**Our Ref** 7521-UA001881-01  
**Your Ref**  
**Direct Line** 029 2092 6812  
**E-Mail** michael.pearson@hyderconsulting.com

**North West Bicester Eco-Town, Oxfordshire  
OCC Planning Comments**

Thank you for considering and responding to the planning application for the first phase of the NW Bicester Eco-town, Oxfordshire. This letter contains further information requested within your response in relation to drainage and street lighting aspects.

DRAINAGE LAYOUT SHT 1 OF 2

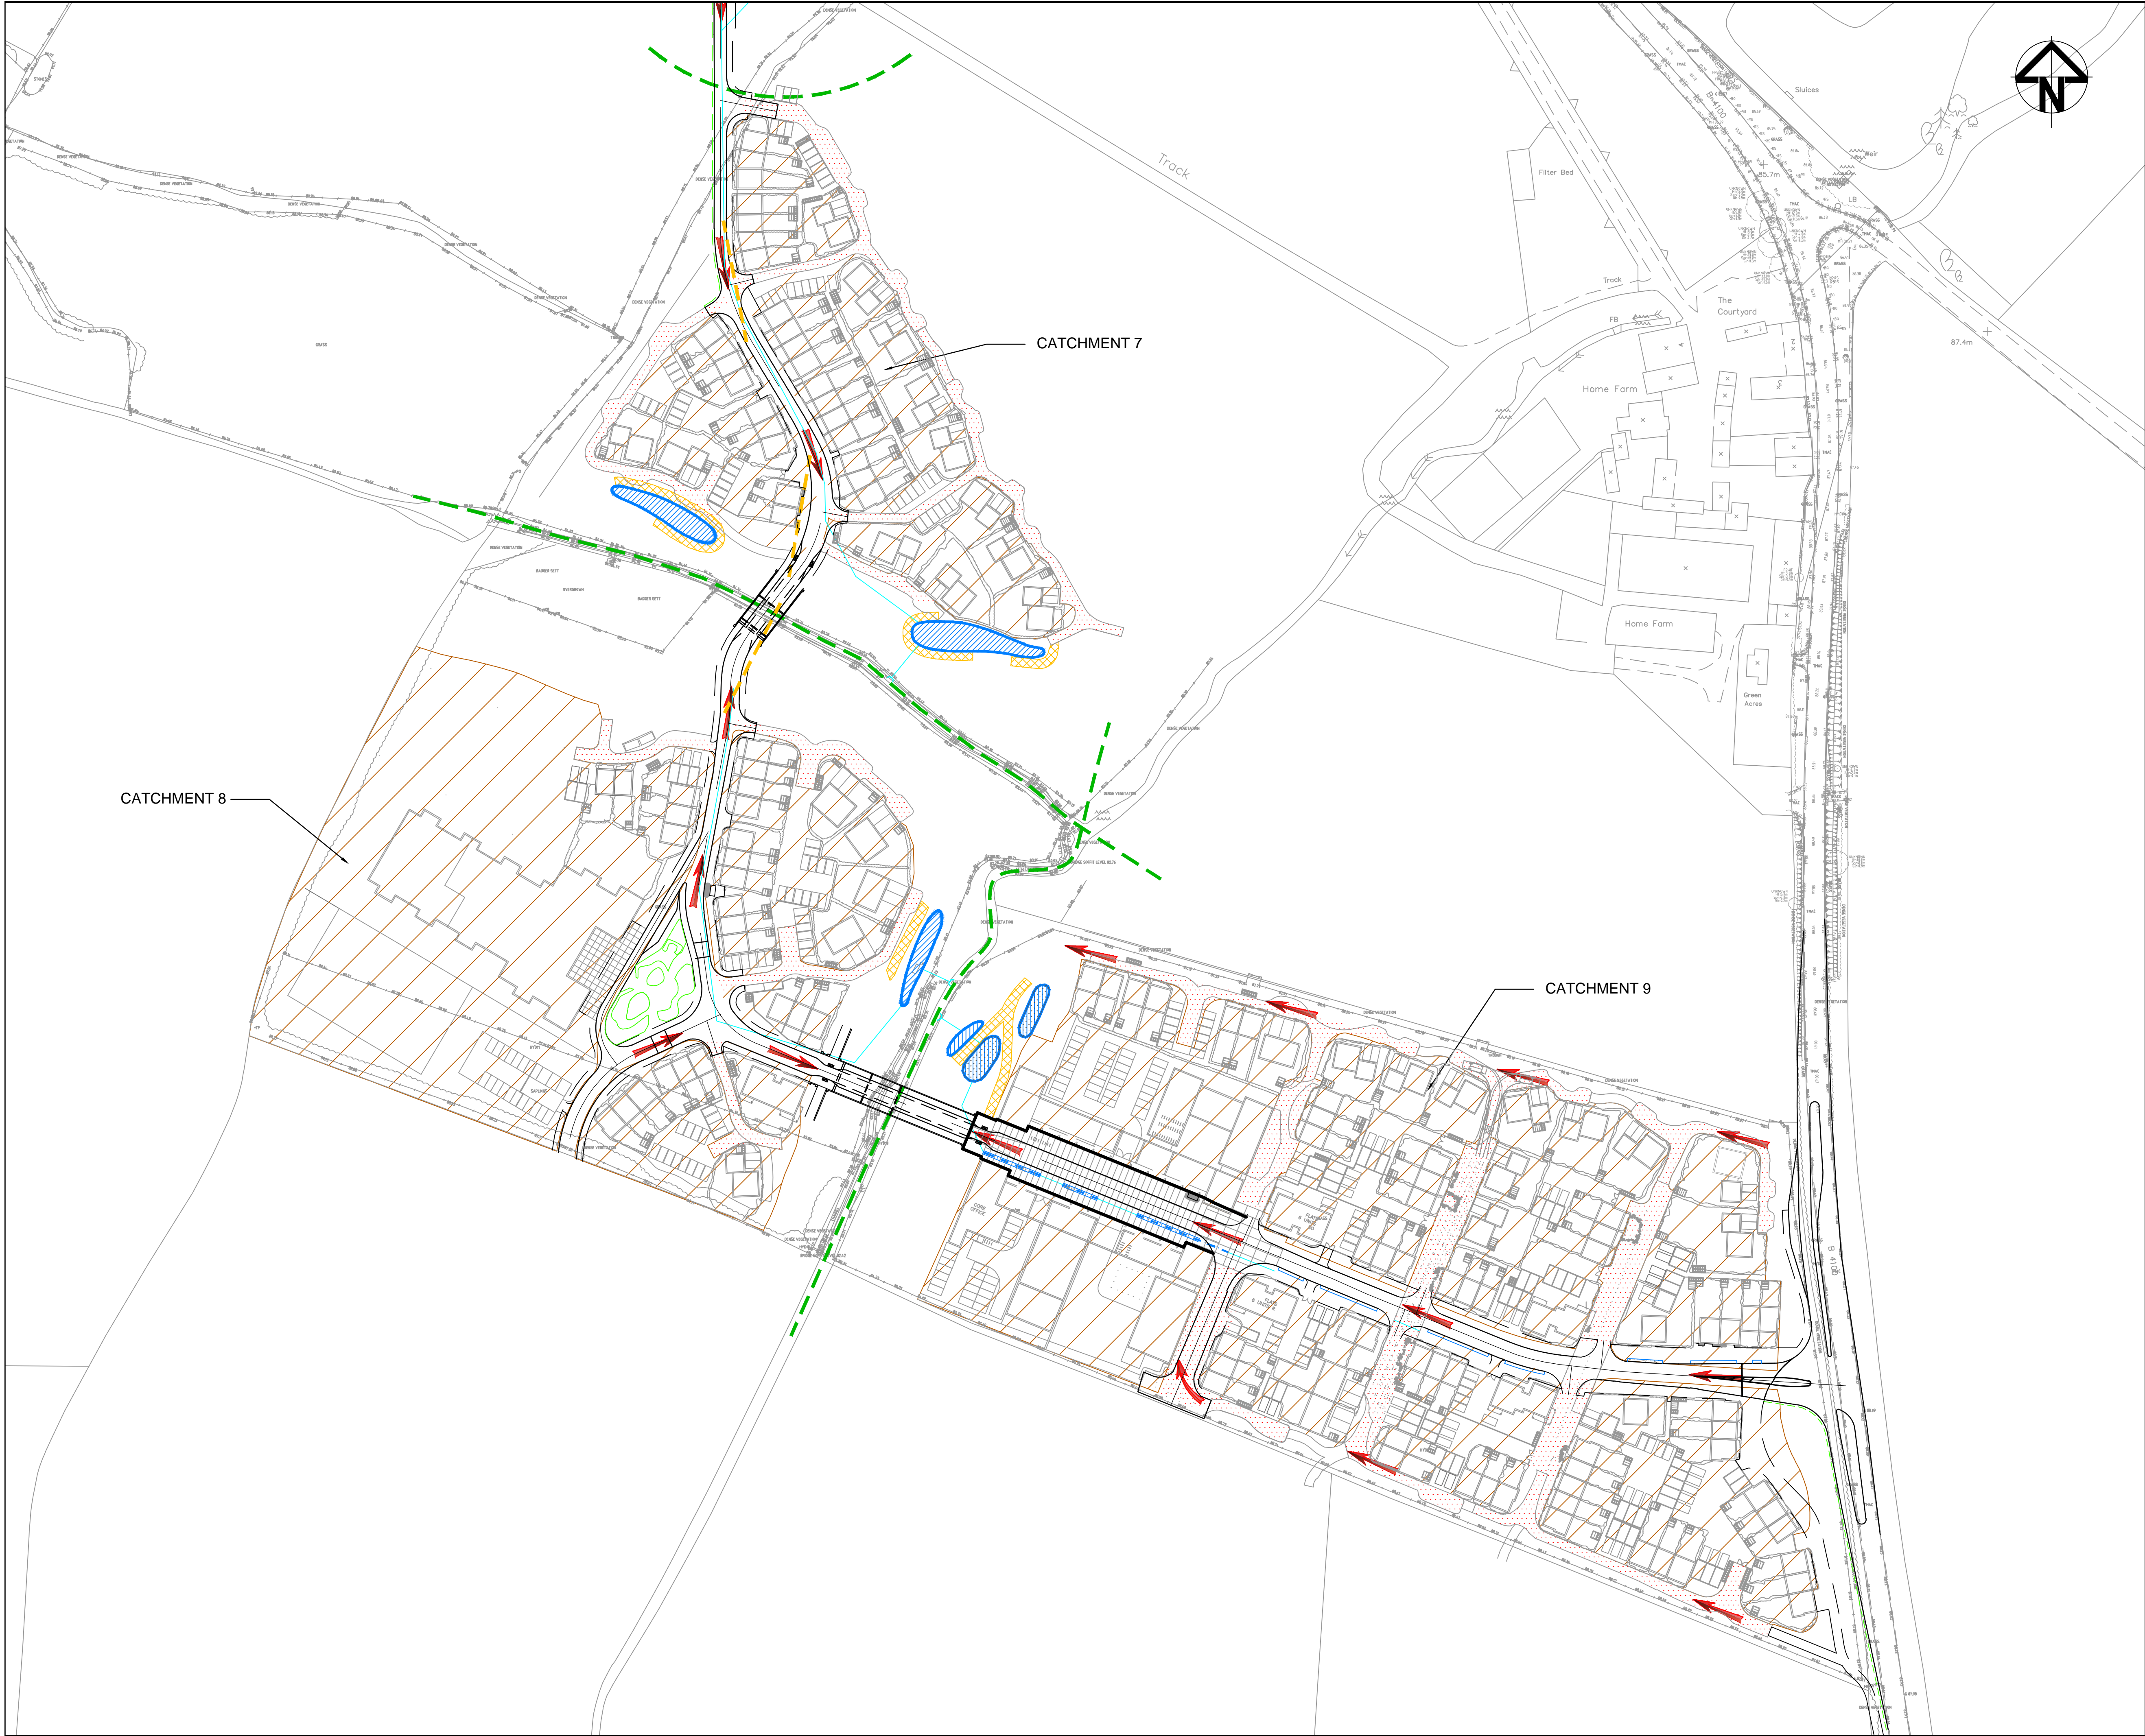
- Drg 8003, 8004, 8005 - Access to ponds / swale for maintenance / footpath, cycleway, footbridge strong enough;  
*Access would be provided to all SuDS features for maintenance. Access arrangements have been shown on drawings 7160 and 7161 (enclosed), and include use of footpaths and grass areas, which would be reinforced as appropriate to suit maintenance vehicles. Access would be provided to suit the shape and size of features with narrow features such as swales requiring vehicular access along at least one side and broader features such as basins requiring access to two or more sides as required. Footbridges are not proposed to be used for maintenance of SuDS features.*

- P(16) - Catchment SUDs Type does not mention porous pavement.  
*The drainage strategy states the widespread use of permeable paving as well as plot soakaways. Areas of permeable paving are shown on the drainage drawings (7160 and 7161, enclosed). Where it is desirable or required to have other SuDS features, they have been listed in the table on page 16 of the Drainage Strategy.*
